DATSUN

Technical Bulletins

1979

Technical Bulletins

FRONT EXTENSION OIL SEAL, 3N71B

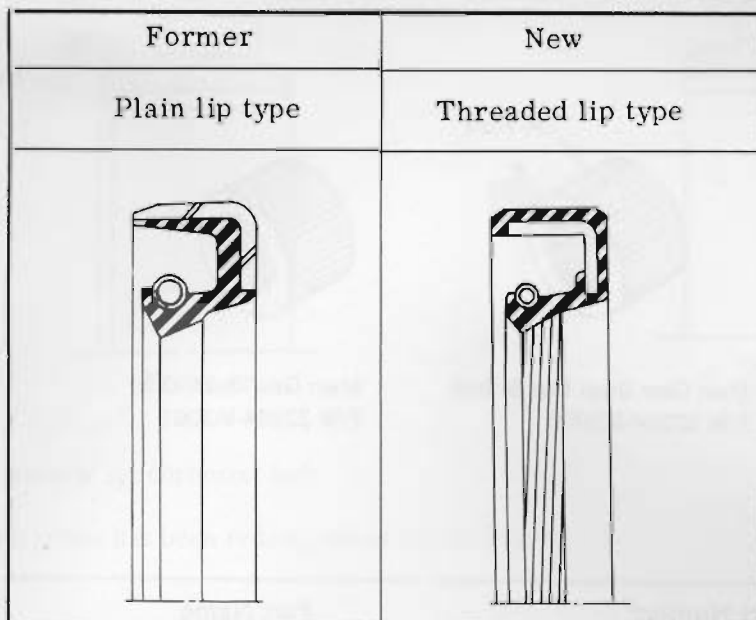
Production Change. The oil seal sealing the torque converter to the front extension of the oil pump on 3N71B transmissions, installed in B210 and 210 models, has been changed from a plain lip type to a threaded lip type seal.

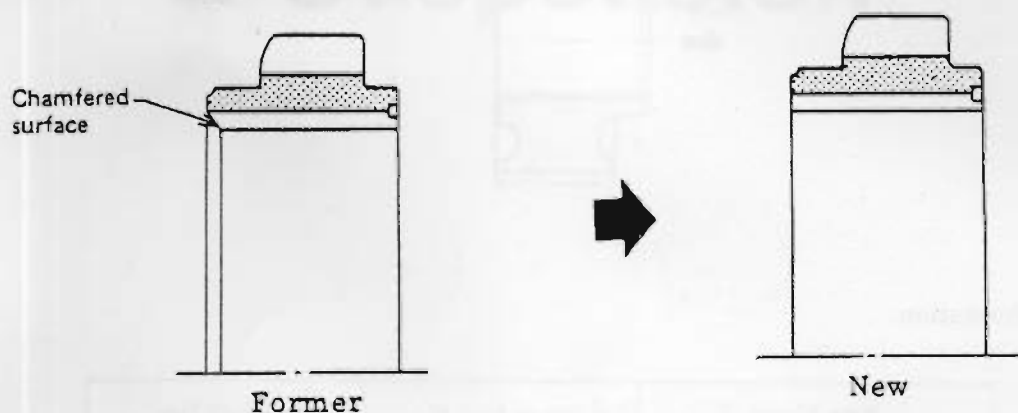
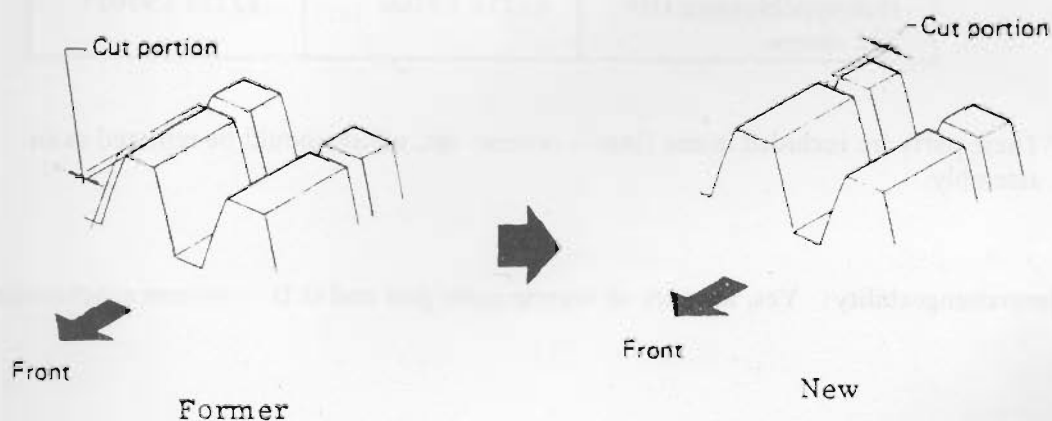
Production Change. To improve operation and standardize parts, the reverse main gear and overdrive — reverse hub have been changed.

The hub spline has been redesigned as shown below.

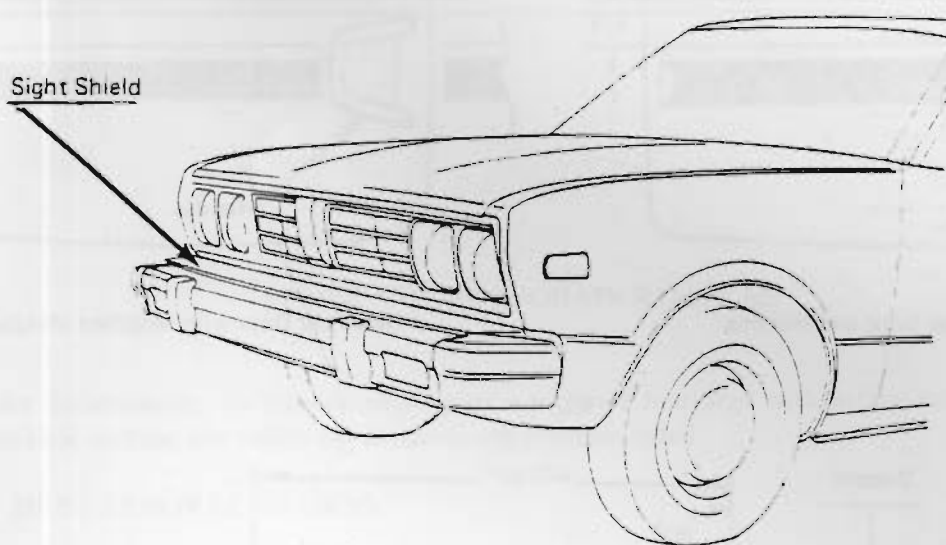
Production Change. To eliminate vibration, a third support has been added to the front bumper sight shield. The part number remains unchanged.

BODY SIDE MOLDING KIT MODIFICATION, 210

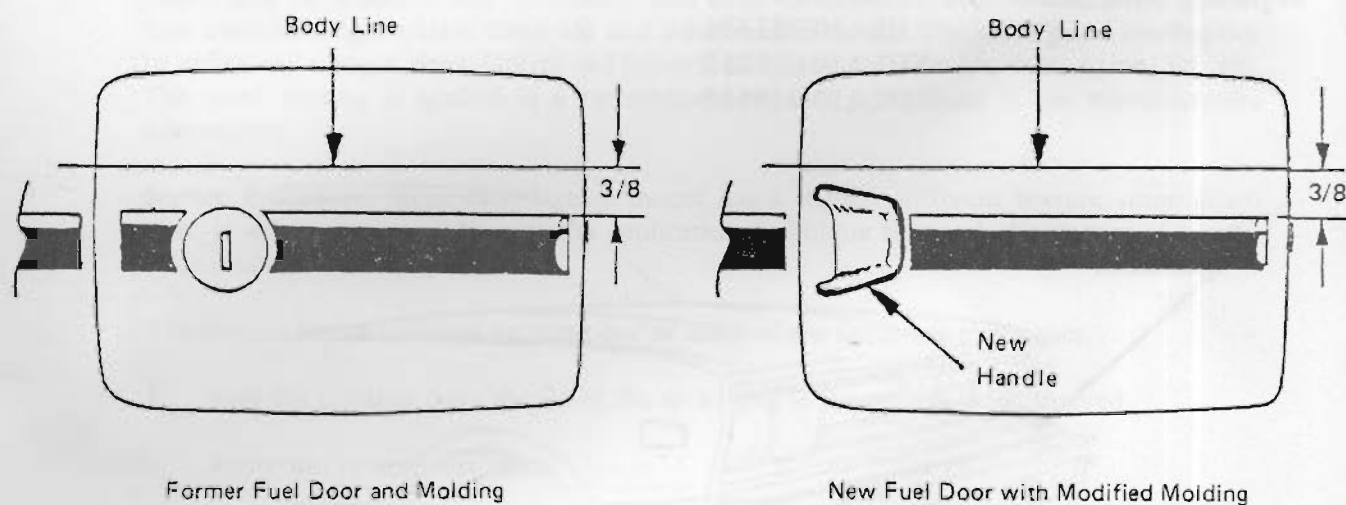
Service Information. Due to a minor product change to 210 models, body side molding kits will have to be modified before installation, as illustrated below.

TORQUE SPECIFICATIONS, REAR BODY MOUNTING, 720

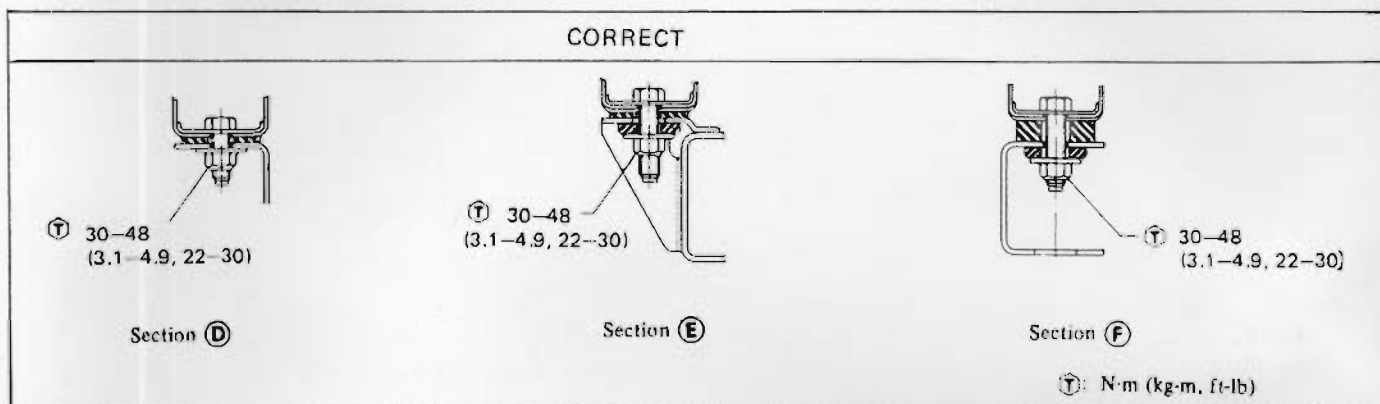
In the Body and Frame Section of the 1980 720 Service Manual, page BF-26, the figures at the bottom, labeled Sections D, E and F, contain incorrect torque specifications. The correct torque specification is 22-30 ft.lbs. Please correct your copy by hand.

HIGH BEAM PILOT LAMP & HEADLAMP CIRCUIT MODIFICATION, MODEL 510

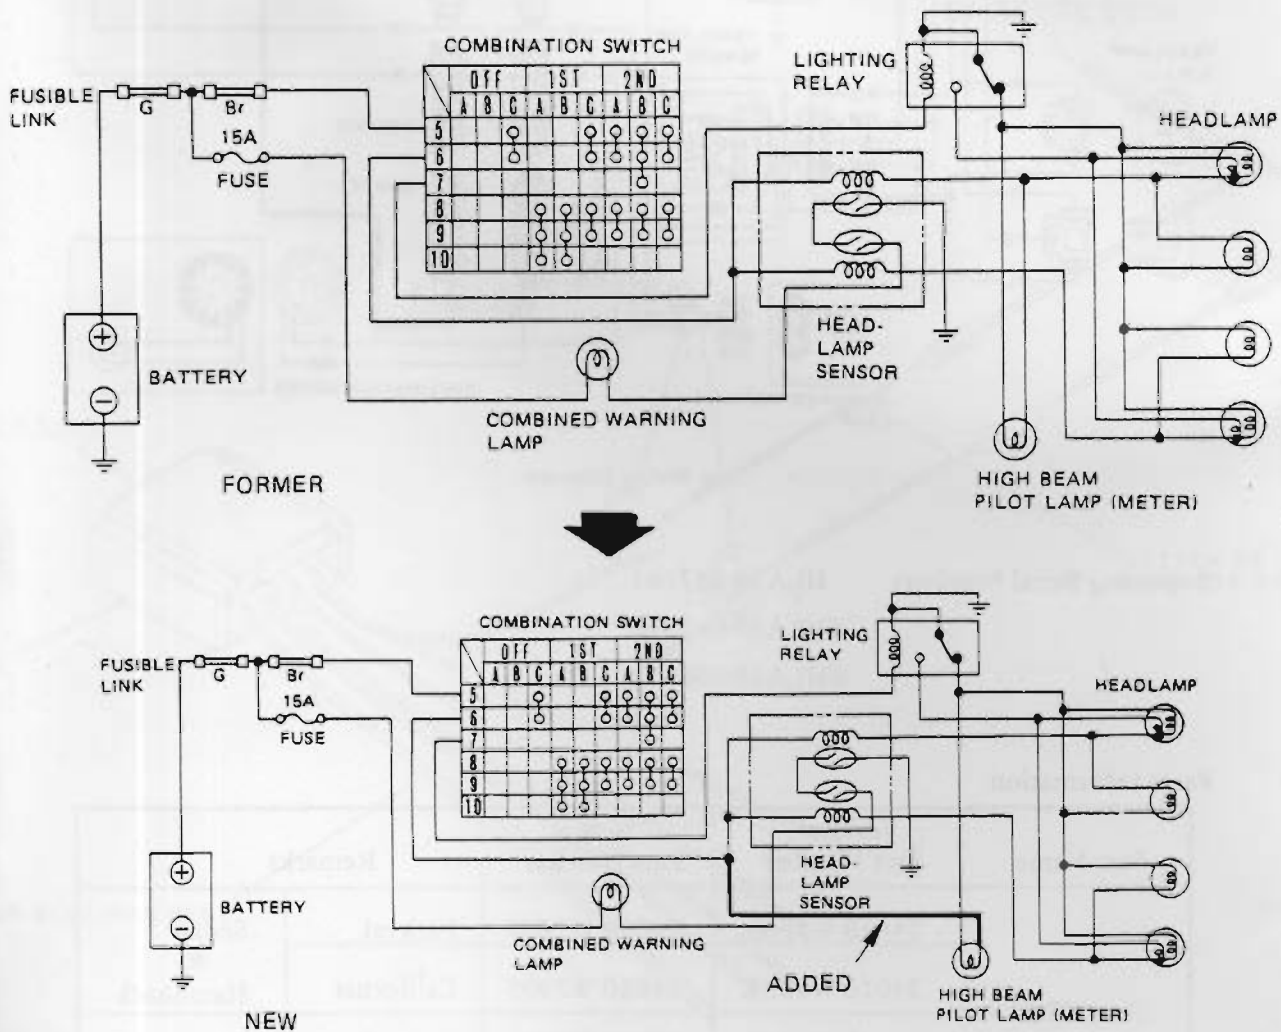
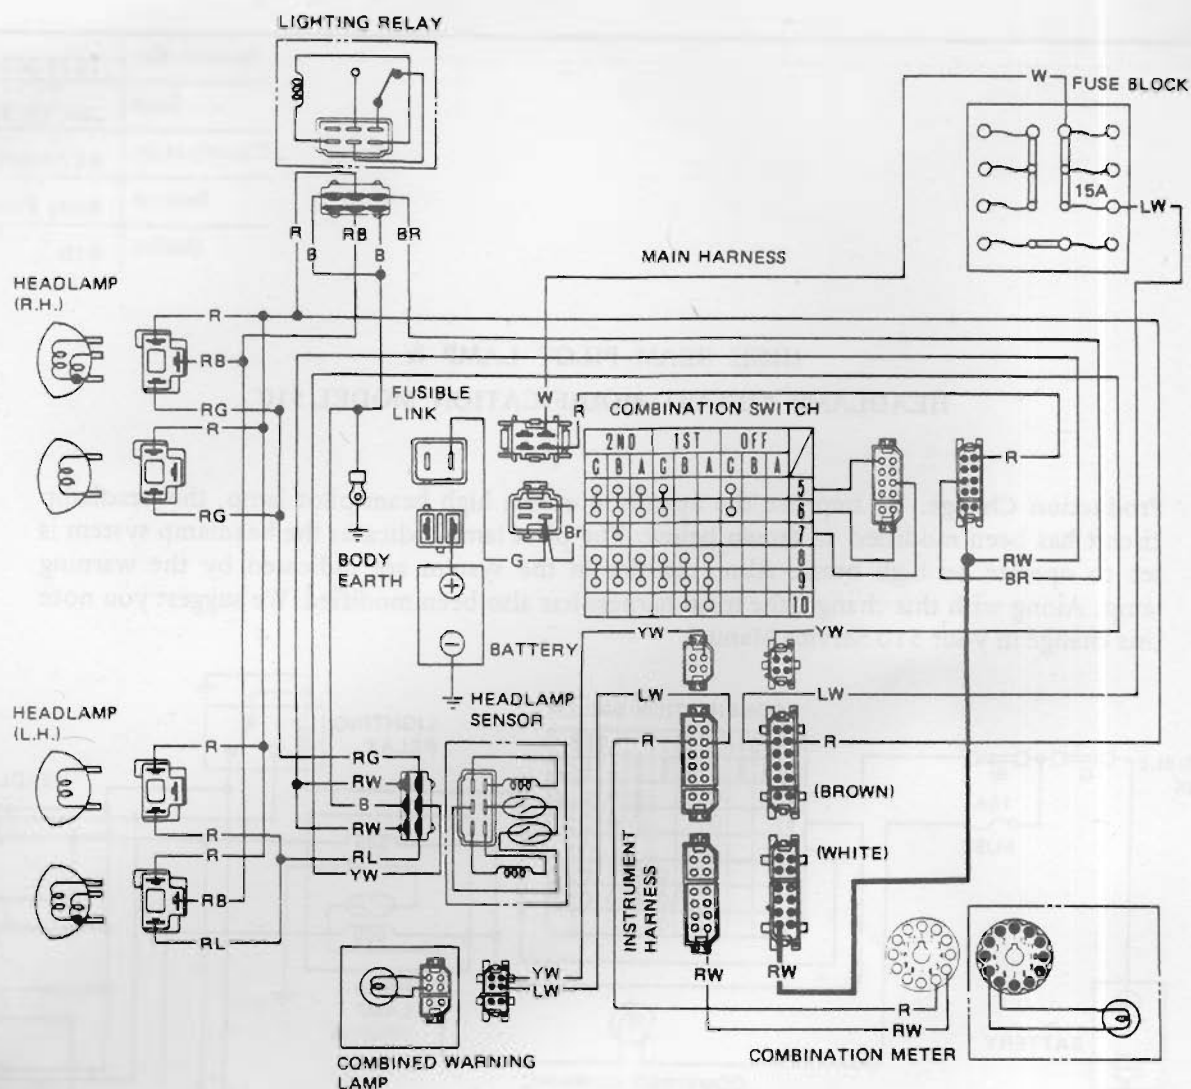
Production Change. To improve the operation of the high beam pilot lamp, the headlamp circuit has been modified as shown below. The pilot lamp indicates the headlamp system is set to operate on high beam. Abnormalities in the system are indicated by the warning lamp. Along with this change, the main harness has also been modified. We suggest you note this change in your 510 Service Manual.

ELECTRIC CIRCUIT MODIFICATION WIRING DIAGRAMS, BODY ELECTRICAL SECTION 1979 280-ZX SERVICE MANUAL

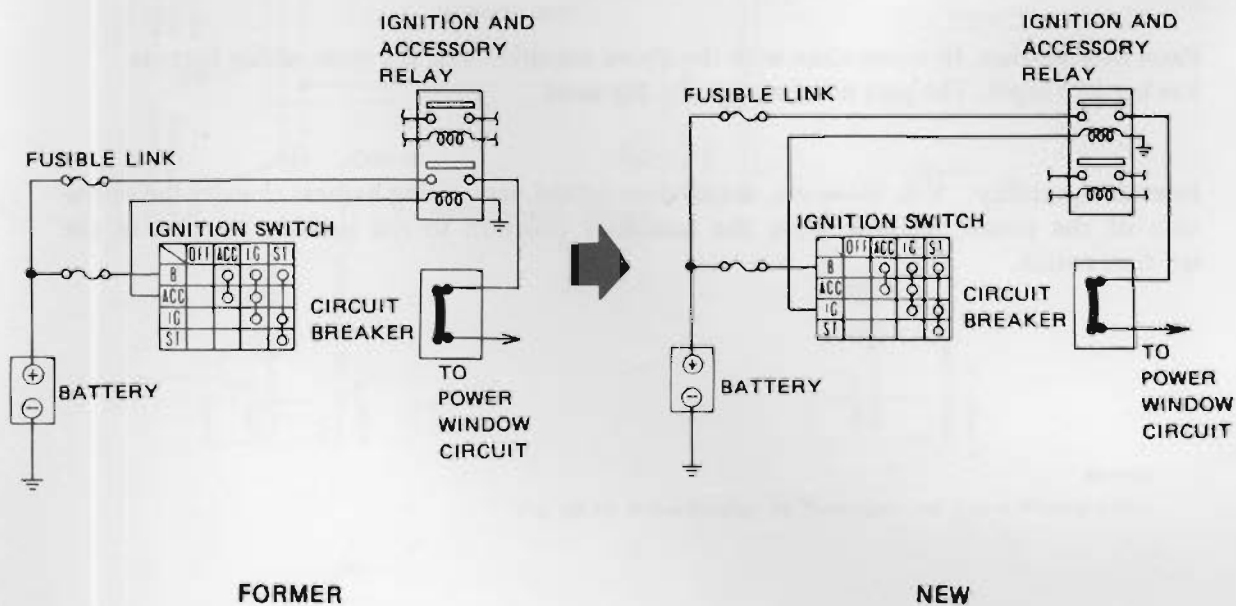
Production Change. To increase the performance stability of the power window and the Automatic Speed Control Device (A.S.C.D.), modifications have been made to the power circuits of the 280-ZX as illustrated below. The enclosed booklet should be kept in your 280-ZX Service Manual to update the Body Electrical (BE) Section.

1. The power window is now activated by current from the ignition circuit rather than the accessory circuit.

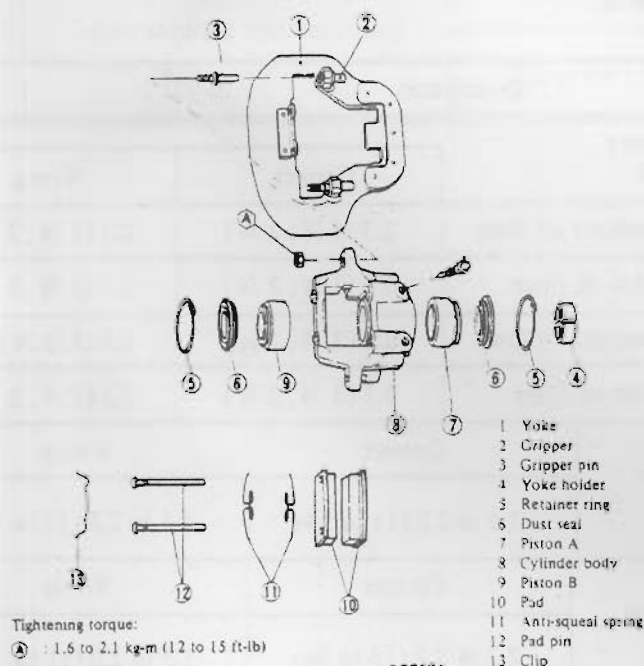
Service Information. The 1979 A10 (510) service manual contains an error on page BR-7. Figure BR-9 illustrates the brake used on 1978 models. The enclosed revised page contains the correct illustration.

FICD ACTUATOR, PRODUCTION CHANGE N10

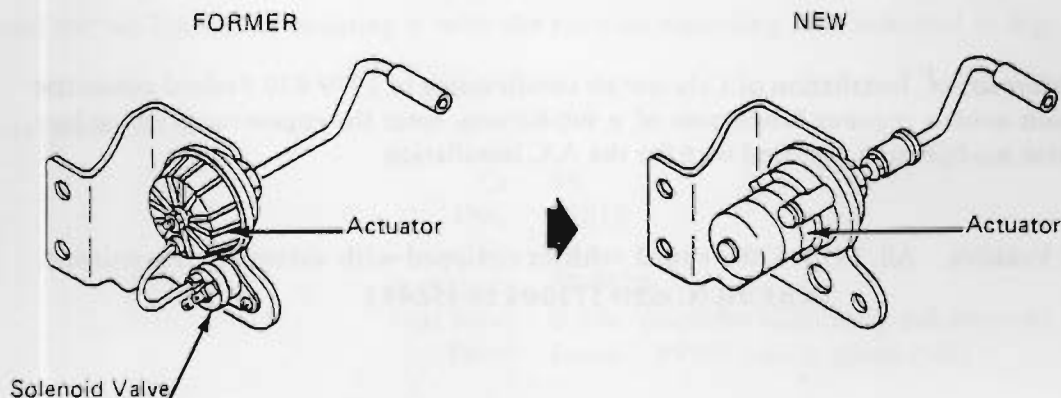
Production Change. To ensure quiet operation, the FICD actuator installed in Factory air conditioned N10 (310) models has been changed.

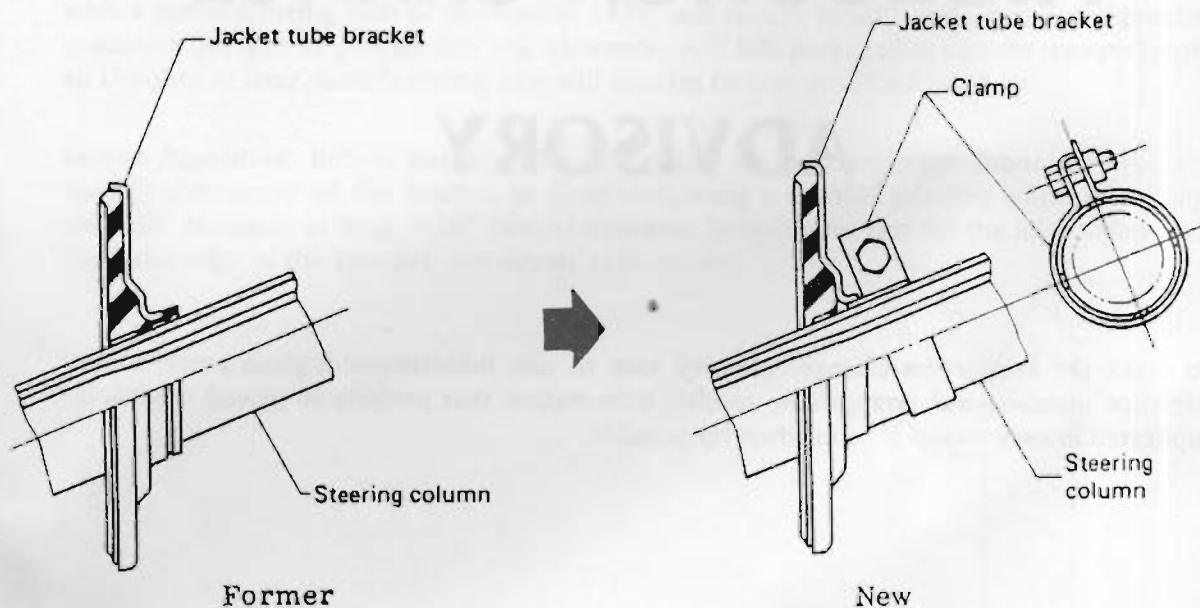
FORMER

NEW

810-001

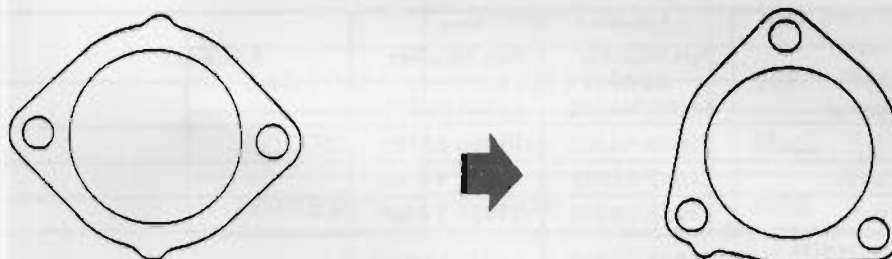
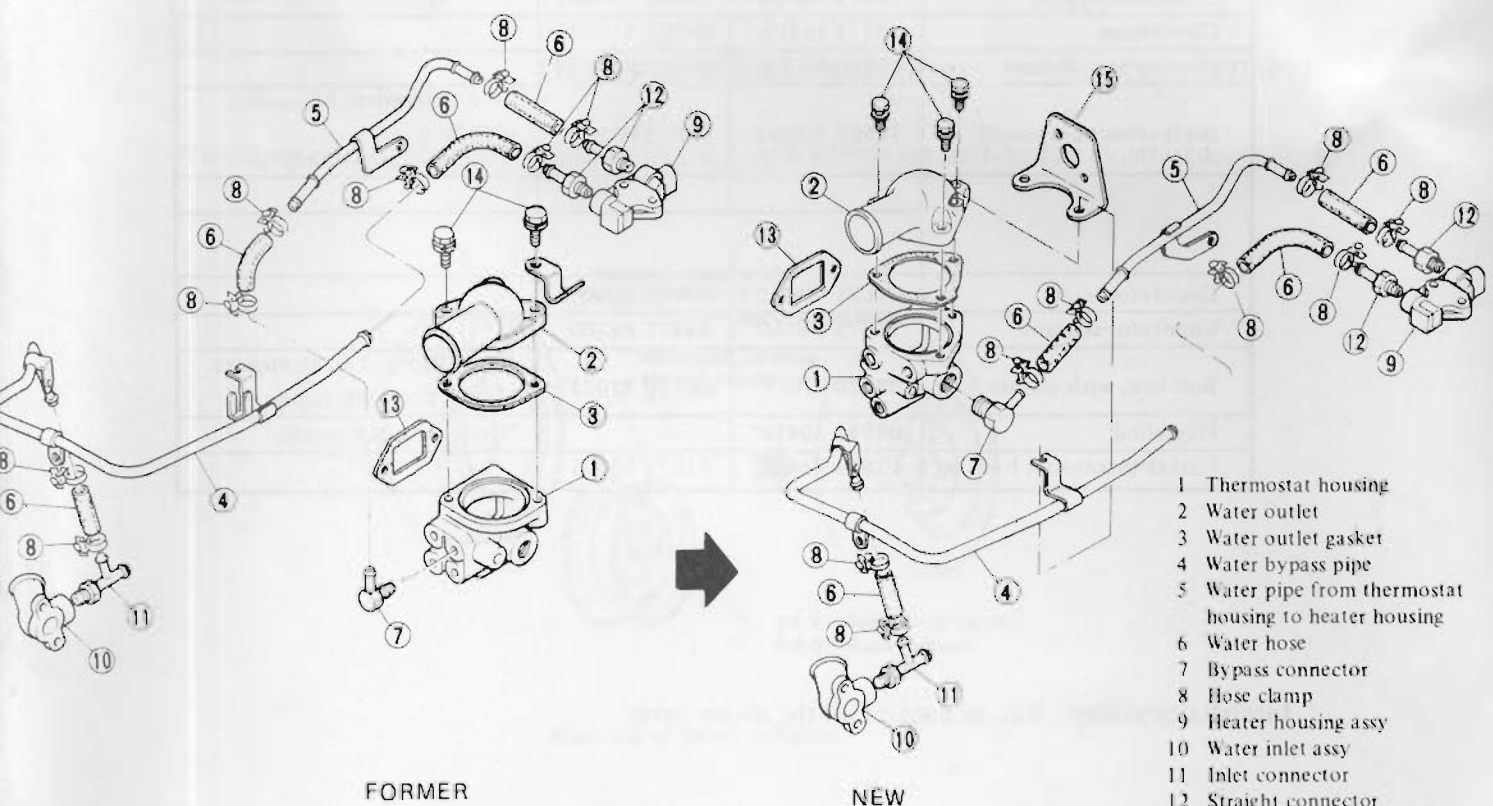
To improve sealing, the water outlet of the L24 engine has been changed from a 2-point to a 3-point mounting, as illustrated in Fig. 1. Along with this change, the inside diameter of the water pipes has been increased from 8mm to 10mm (Fig. 2).

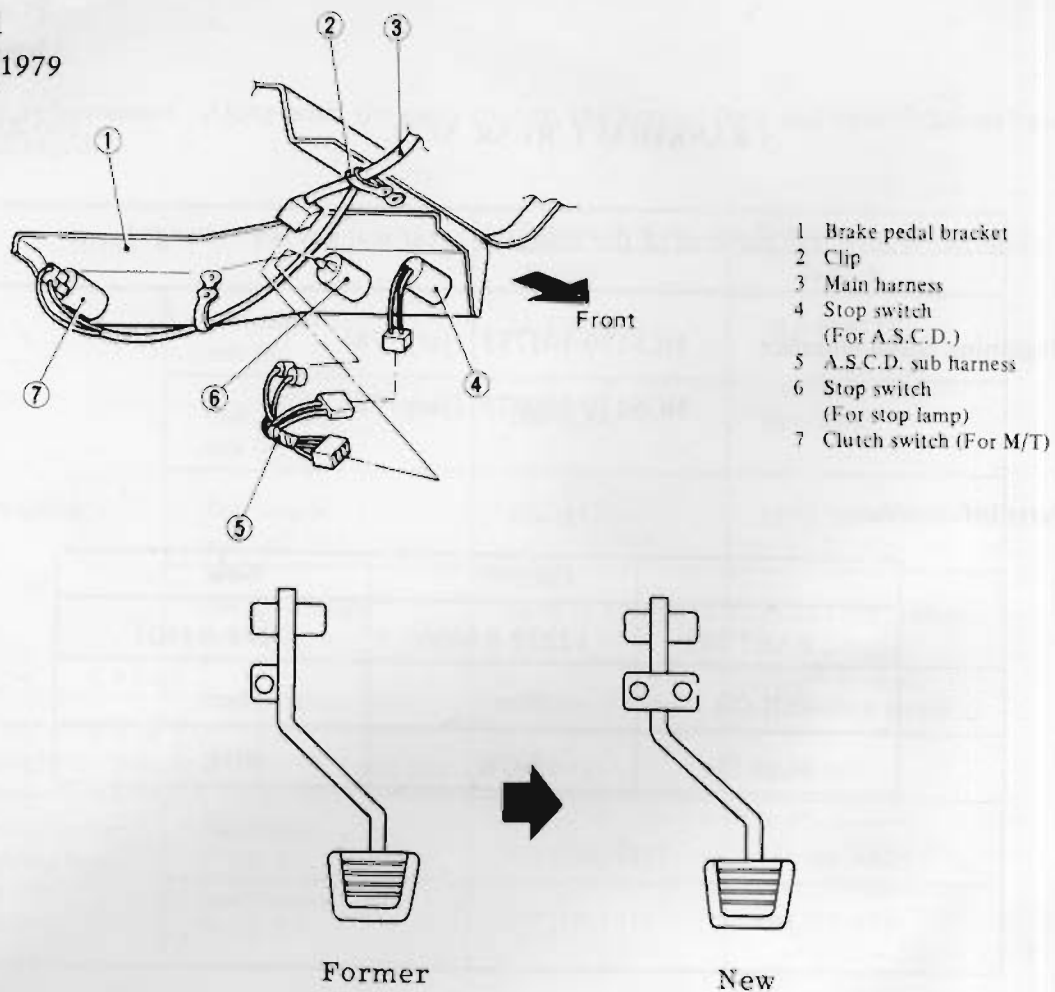
To standardize parts, the combination ASCD set release switch (stop switch) and stop lamp switch has been changed. The combination stop switch has been replaced with a stop lamp switch and an ASCD set release switch. To accommodate the additional switch, the brake pedal and bracket have been modified and an ASCD sub harness has been added.
